**MINUTES OF MEETING – Construction Reference Group (CRG)  
Murdoch Drive Connection  
Meeting #5**

Bibra Lake Residents (south-west)

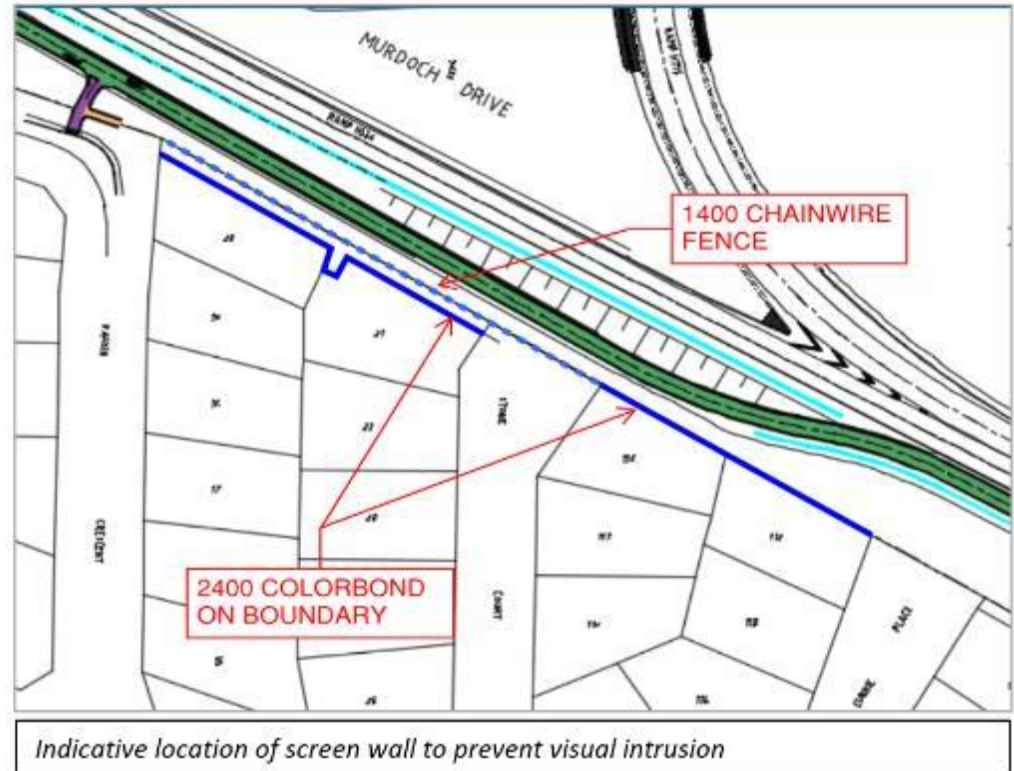
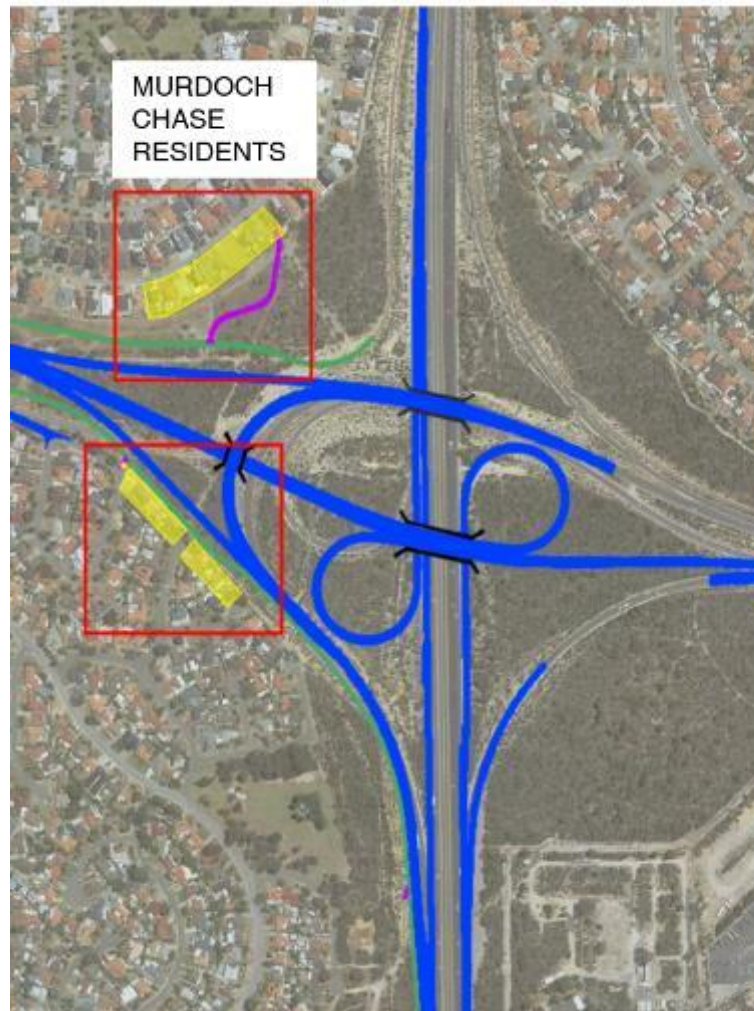
- Four residents
- ✓ Solution achieves passive surveillance for path users (CPTED)
- ✓ Chainwire fence assists in crime prevention via cul-de-sac

NO.	ITEM / DETAILS
4	<b>QUESTIONS AND ANSWERS</b>
Q	Why not use a solid wall in place of the chainwire fence proposed at Pausin Crescent? What has changed with an earlier commitment to provide a solid barrier close to the PSP?
A	<p>There is a fibre optic cable in the verge that limits the use of a larger structure in this location. MRWA's Asset Management group prefers chainwire to avoid graffiti impacts too. We aim to take on board community feedback in situation like this but services were a key constraint.</p> <p>Additional potholing was completed after our initial discussions and identified the need to avoid larger wall structure resulting in the change.</p> <p>John Amanatidis advised that a 2.4m colorbond fence on the property boundary is not supported on boundary. Shane advised that if the resident doesn't want the colorbond fence it won't be provided.</p> <p style="text-align: right;"><b>ACTION: Shane and Jarrid</b></p>

The colorbond fence will provide a visual screen with the chainwire fence providing a physical barrier to manage local area access with connectivity to the PSP provided at Pausin Crescent.

**Street Lighting**

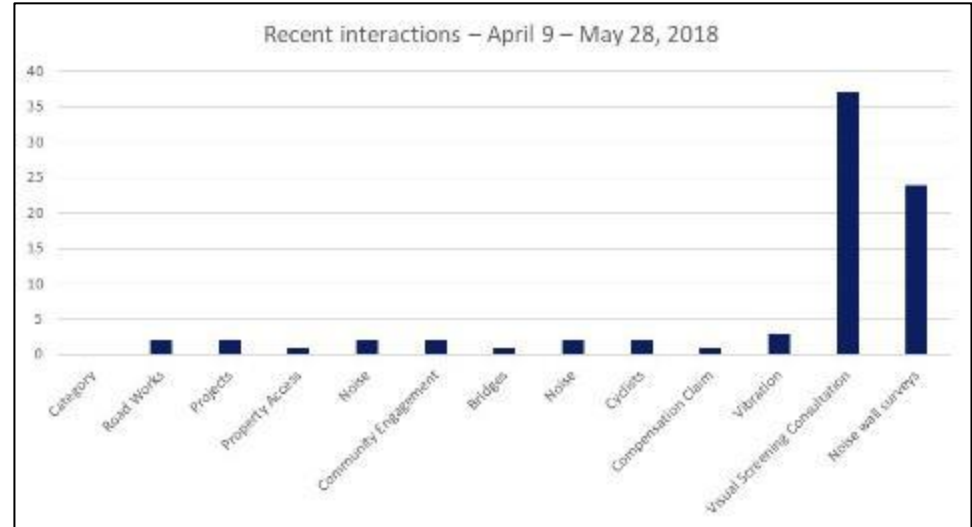
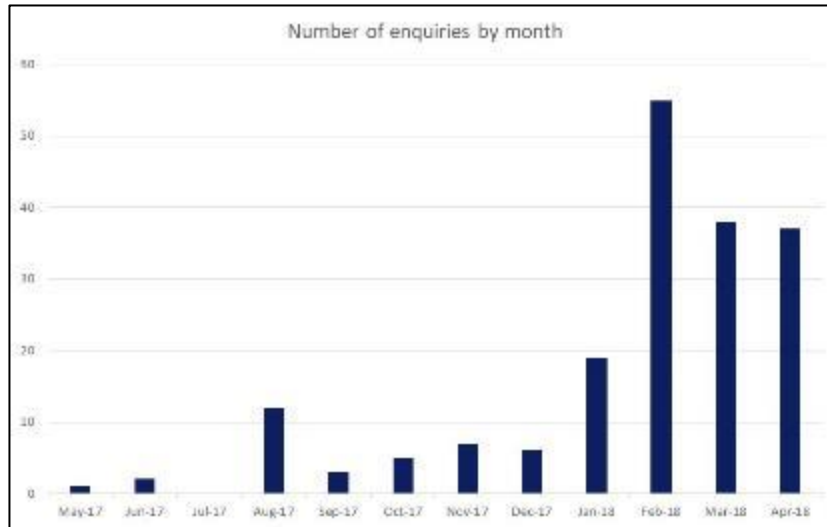
- Light poles are typically installed at 50m intervals.
- Light spill analysis is underway now. Further information will be provided at a future meeting.
- Could we use LED lighting? MRWA uses Western Power/MRWA approved solutions. LED is more direct light stream and uses less energy. Could we please seek opportunities to use them here?
- Include as future discussion topic.

- 12.5m double outreach light poles located in the median as shown in the image
- Same as the ones on Farrington Road (250 watt high pressure sodium)

- 7m tall single outreach light poles
- Same as the ones currently on the path network (150 watt high pressure sodium)
